CITY OF DOVER

PLANNING TECHNICAL REVIEW COMMITTEE –AGENDA

1. 10:30 AM - 11:30 AM: Site Review for CESO (Owners: 914 Central Avenue, LLC), Assessor's Map 38, Lot 20, zoned C, located at 914 Central Avenue. (Proposal is for Hang Ten Car Wash development that will consist of a 4,400-sf building, sixteen (16) vacuum spaces, and two (2) employee parking spaces. Two (2) related Conditional Use Permit applications would also appear before the Planning Board. (SITE-2023-0008, COND-2023-0045, & COND-2023-0046)
[This item was previously heard on August 17, 2023 and December 21, 2023.]

PLAN SNAPSHOT REPORT SITE-2023-0008 FOR CITY OF DOVER, N.H.

SITE PLAN

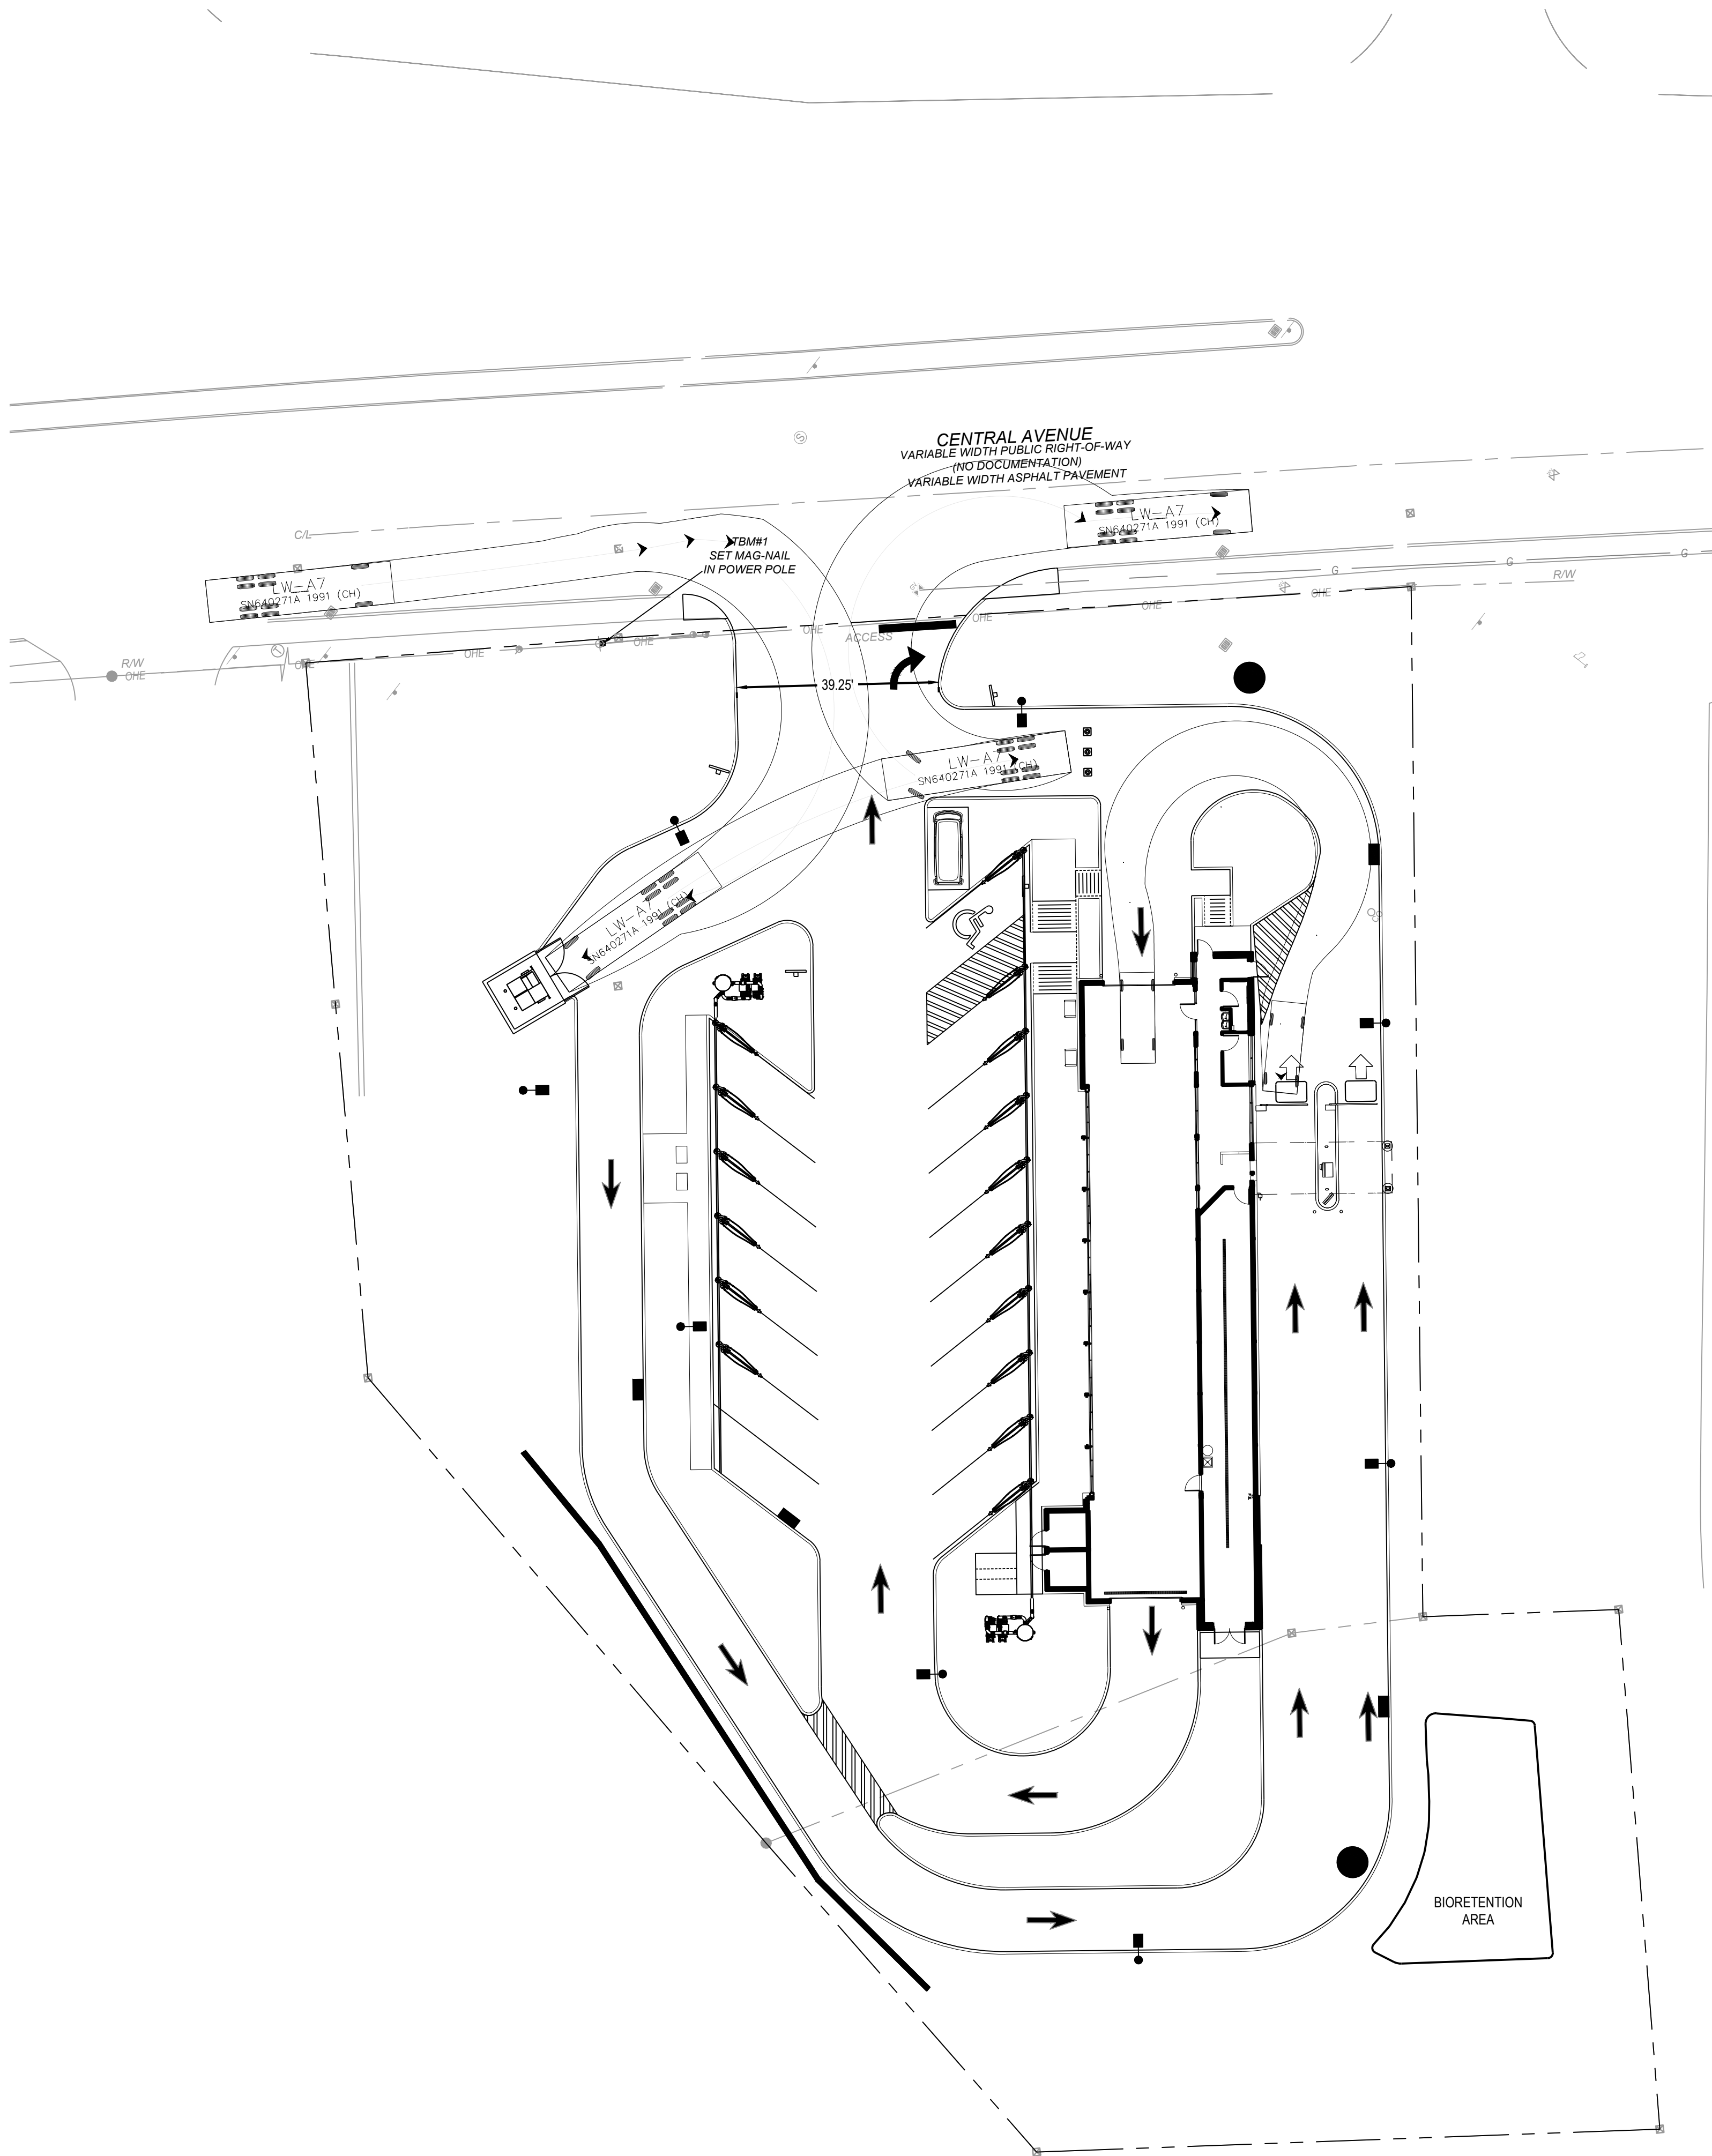
Response: Performed revision as requested by city.
- 4) C3.0:
 - a. Call out existing paved sidewalk tipdowns to be reconstructed. Repair any and all damaged paved sidewalks.

Response: Wayfinding signs have been added. See Sheet C3.0
 - d. Provide pavement markings at exit to indicate right-turn out, and add stop bar.
Response: Pavement markings and stop bar have both been added to C3.0.

Response: Note added to the site plan, Sheet C3.0.
 - k. Provide dimensions of striping for the parking spaces.
Response: Dimensions provided on C3.0.
 - l. Provide dimensions of drive aisle, drive-thru, etc.

Response: Dimensions provided on C3.0.
 - m. Indicate what the aprons at the entrance and exist of the wash tunnel are. Are the aprons to be concrete pads?

- p. Coded Note 20 not shown.
Response: Coded note is shown on northern face of the building towards Central Ave.
- 5) C4.0:
 - a. Confirm if there will be potential ponding at the entrance to the wash tunnel. Appears that there is a trench drain; confirm water goes to reclaim tank.

- 8) Are trash receptacles provided only as shown in Note 14 on Sheet C3.0? These do not appear to be accessible to the ADA parking space.

GRADING & DRAINAGE
PLAN

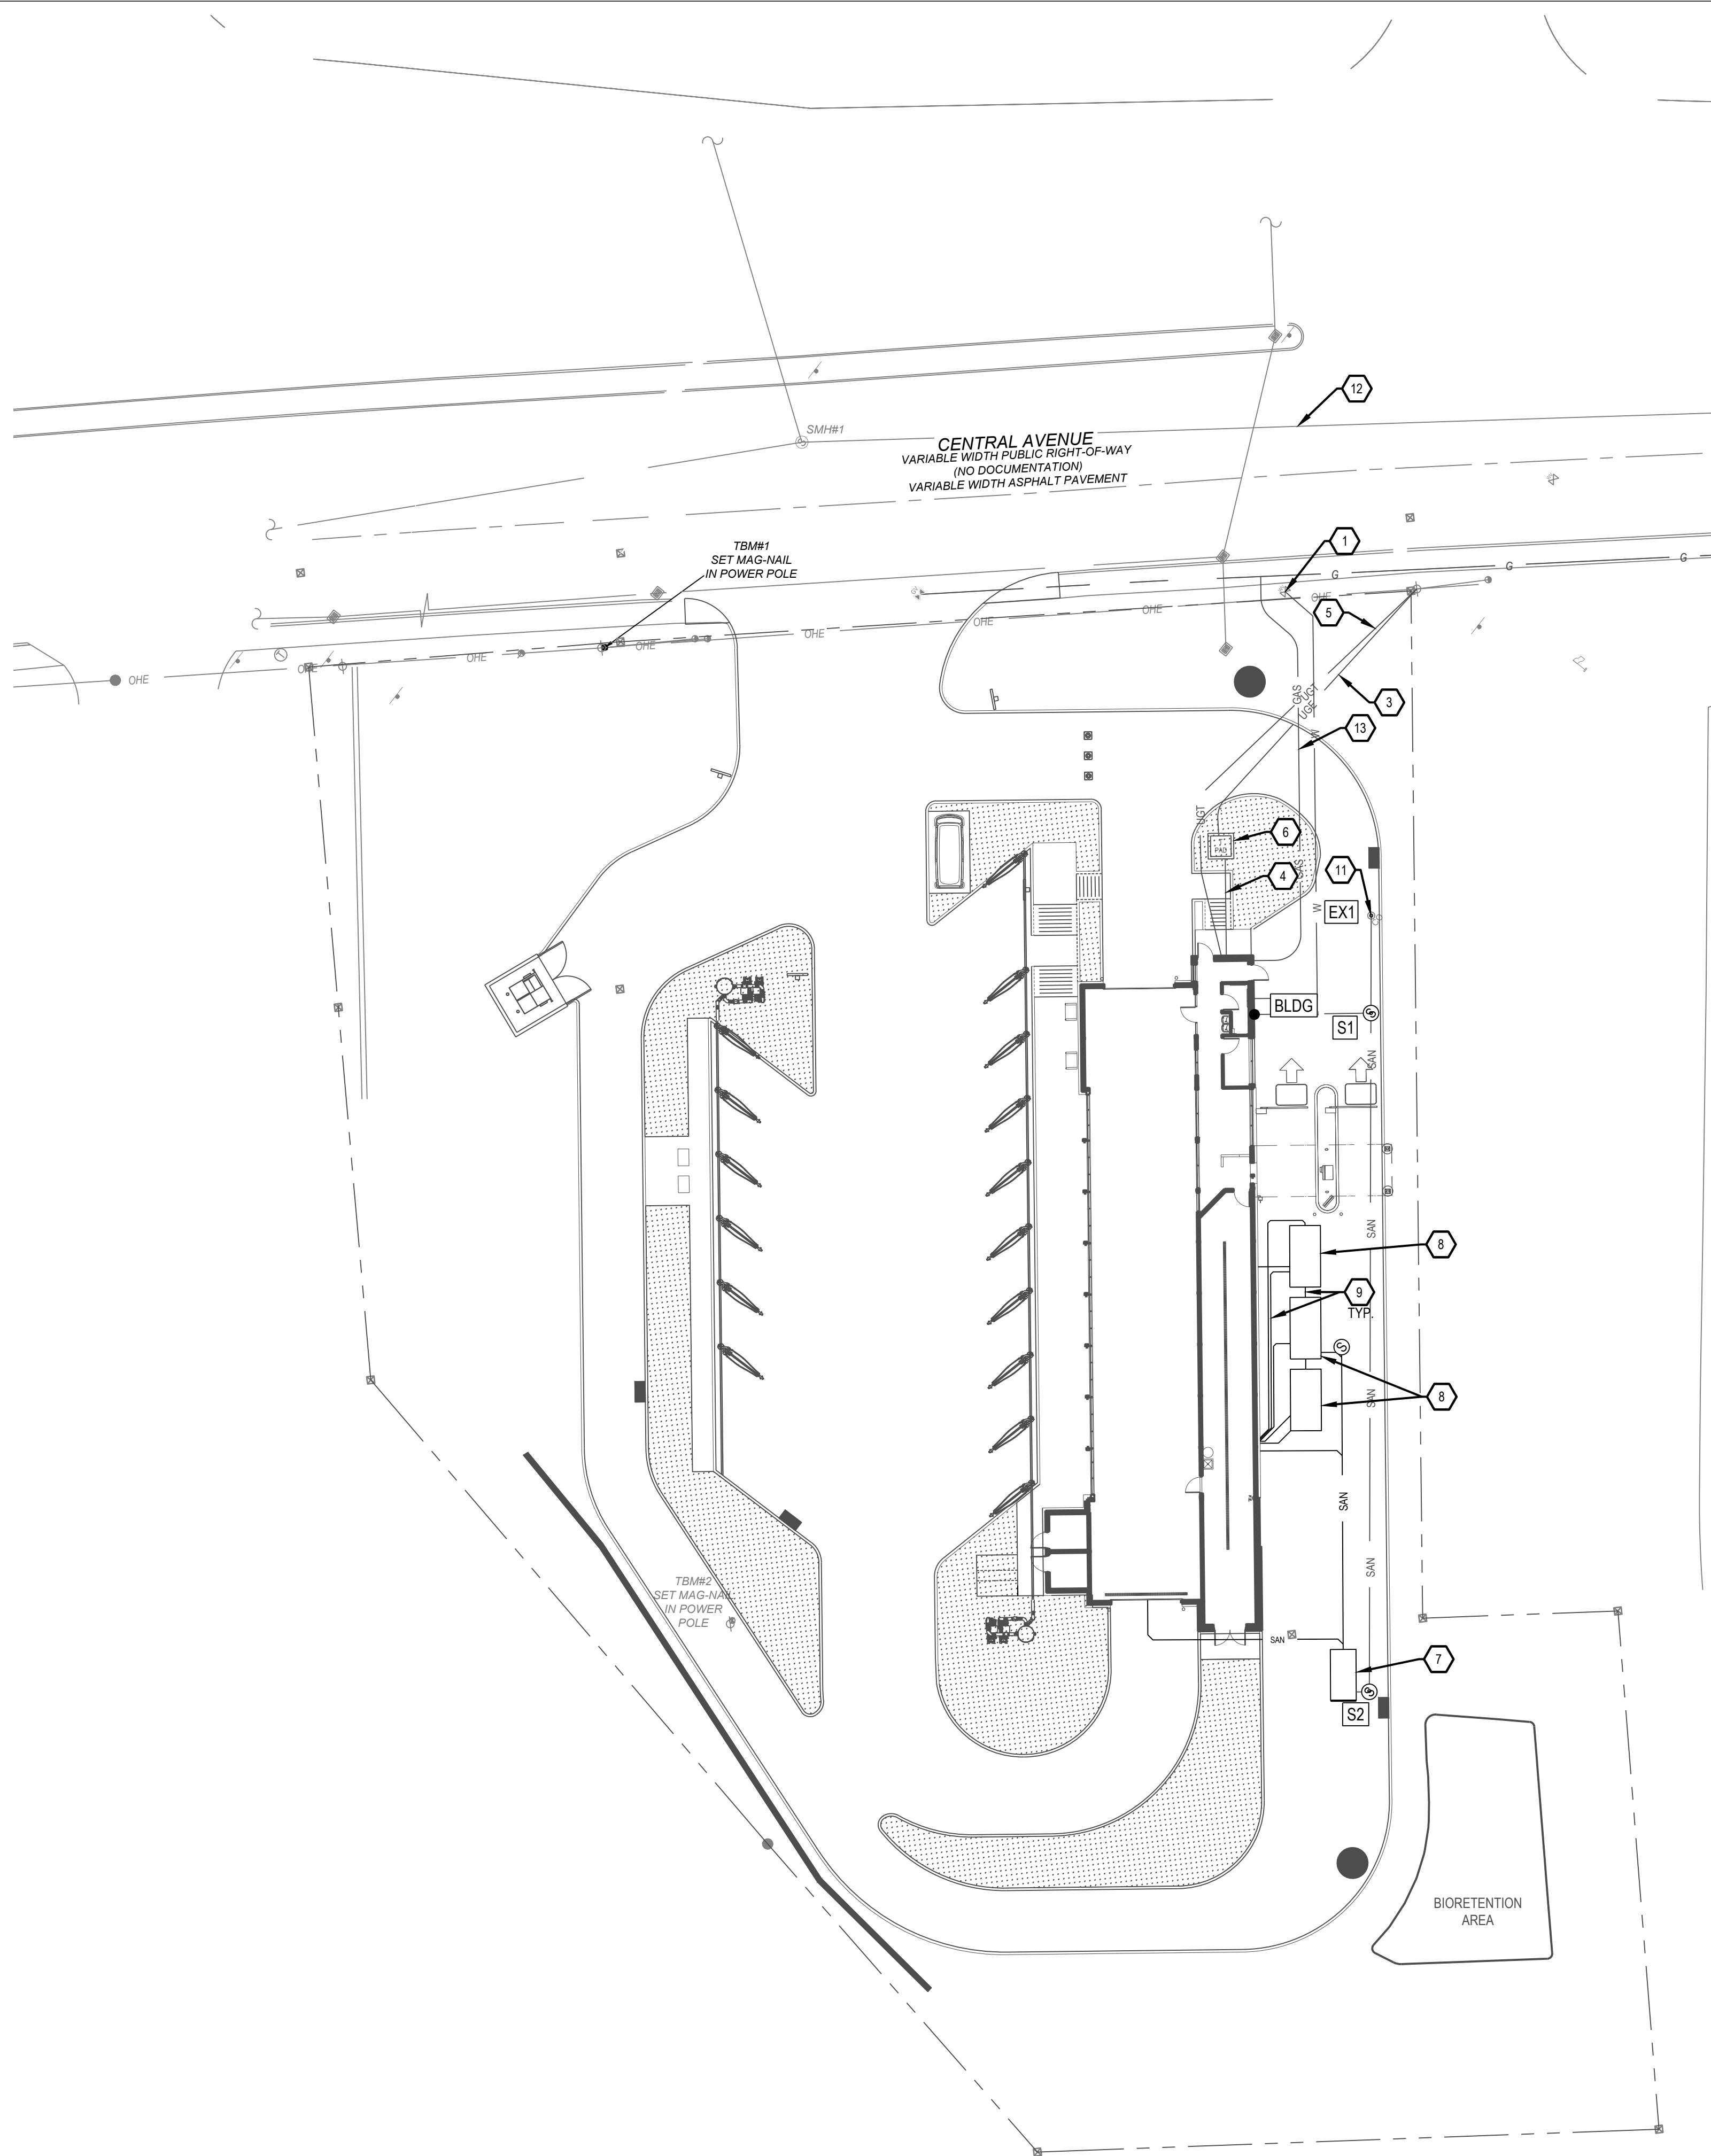
Response: Hydrodynamic separator detail added.
 - e. Coded Note 2 - A detail of the subdrain has not been provided; there is no sheet C600. Show subdrain on Sewer Pipe Table, and revise Storm Sewer Structure Schedule as necessary to show inverts of subdrain. Extend subdrain full length of pervious paver areas.

Response: Added coded note 2 stating the information provided in the comment.
- 6) C5.0:
 - a. Existing sewer main is 12" VCP and existing water main is 12" DI; within Central Avenue.

UTILITY DETAILS

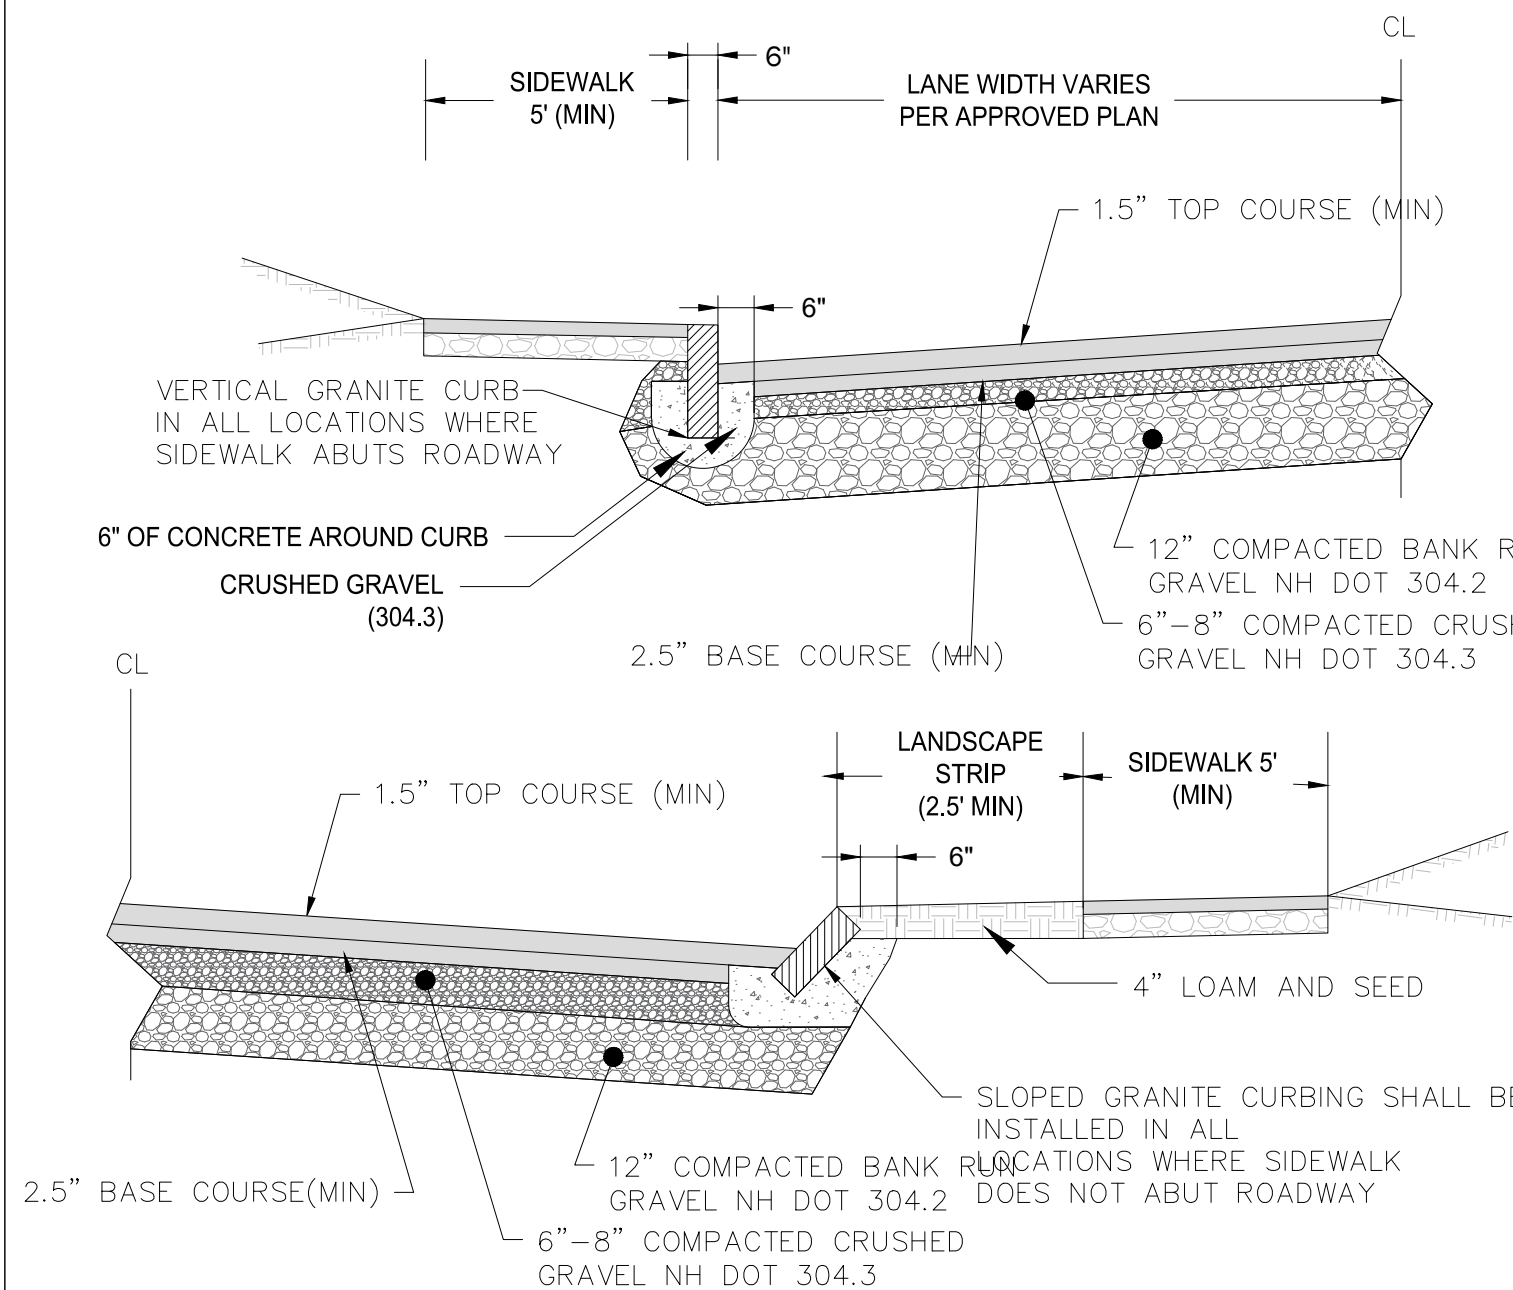
Response: All cleanouts have been replaced with SSMH.
- 7) C5.1:
 - a. Utility Pipe Trench and Bedding – Compare detail with City standard detail for public utilities
